Part 3A Development for 8 Hearn's Lake Road Woolgoolga

**MP 08-0005, The Pines Caravan Park
Lot 106, DP 1144462, No. 8 Hearnese Lake Road, Woolgoolga**

Major Project MP 08-0005 The Pines Caravan Park

Re: Proposed Extension to Existing Caravan Park at Lot 2 DP1031068 and Lot 2 DP1031968 – ‘The Pines’ 8 Hearnese Lake Road, Woolgoolga MP08_0005

**THE PINES AND WATERSIDE CABINS
COMMUNITY PLAN (09-11-06)**

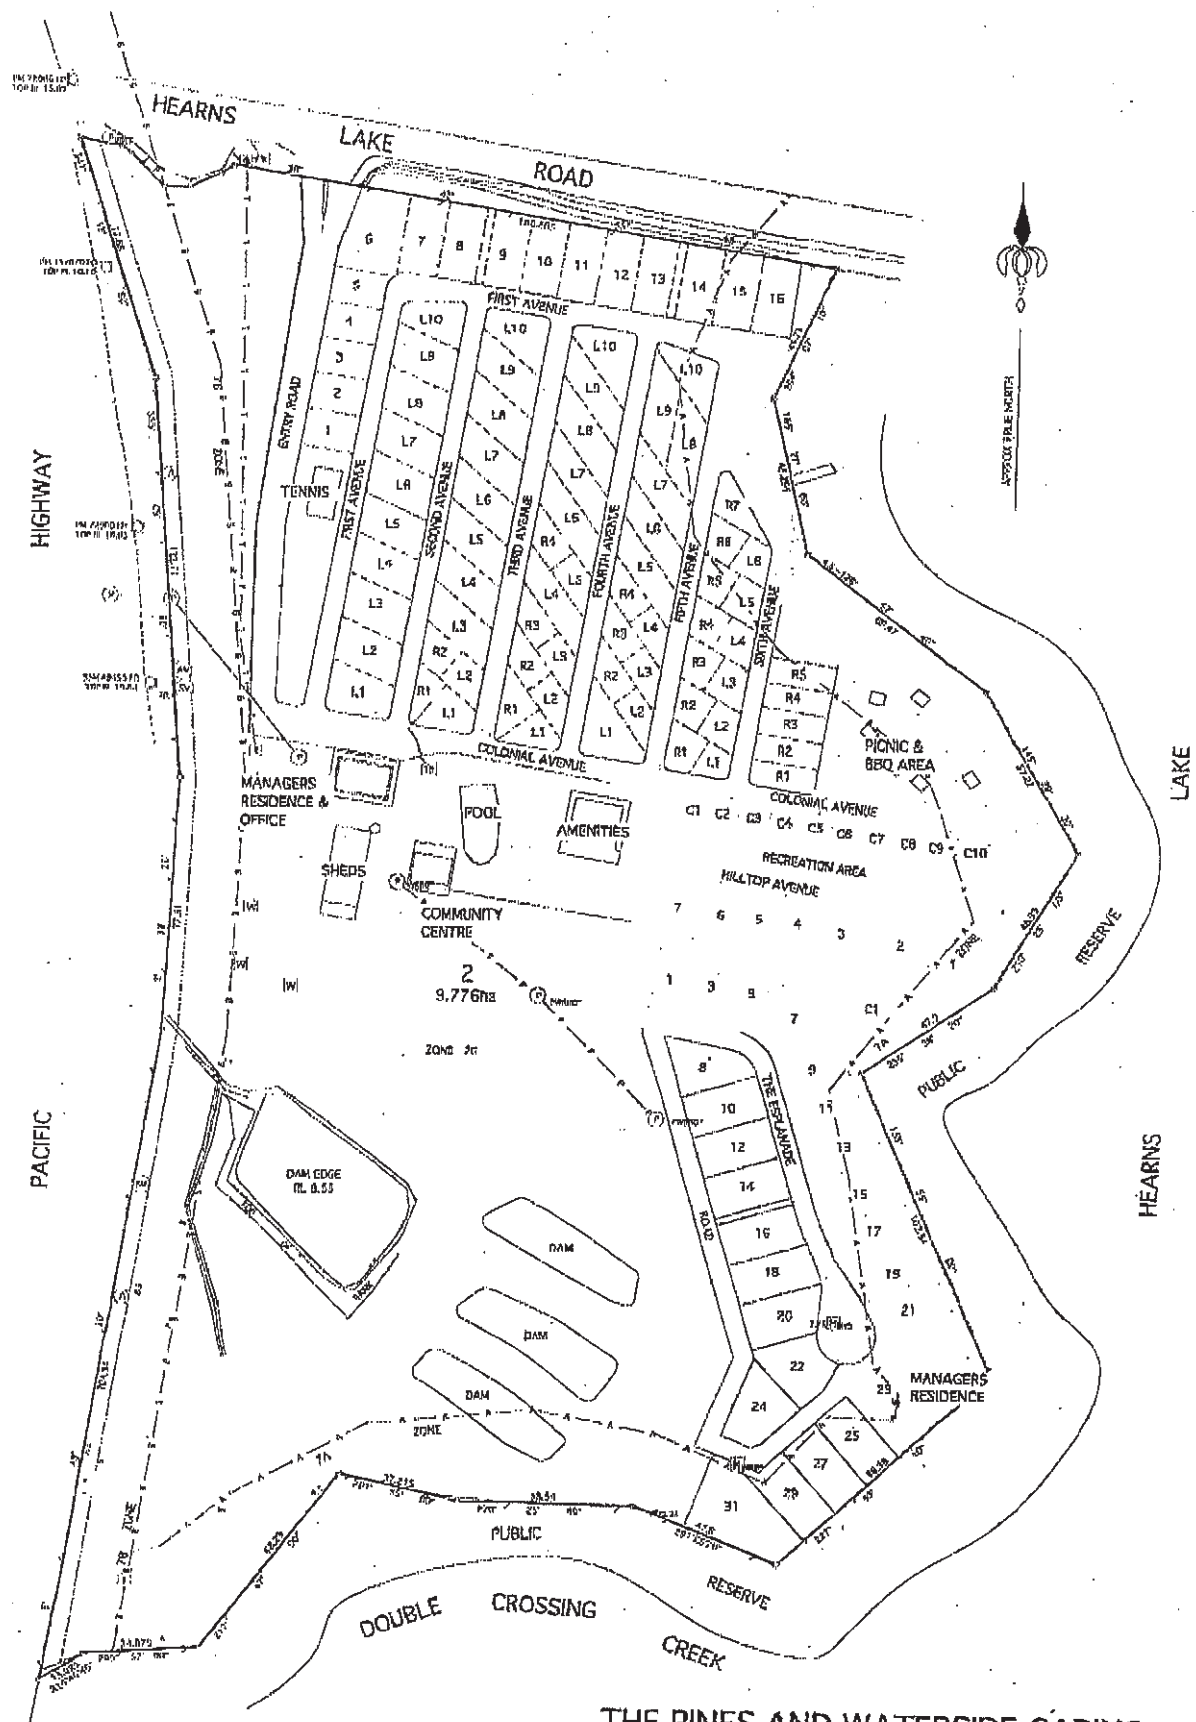
- A. The existing relocatable homes and associated outbuildings, structures, services, parking, etc located on Sites 25, 27, 29 and 31 as shown on drawing 09-11-06 "The Pines and Waterside Cabins Community Plan" being removed by no later than 1 April 2011. These sites shall revert to an environmental buffer area.
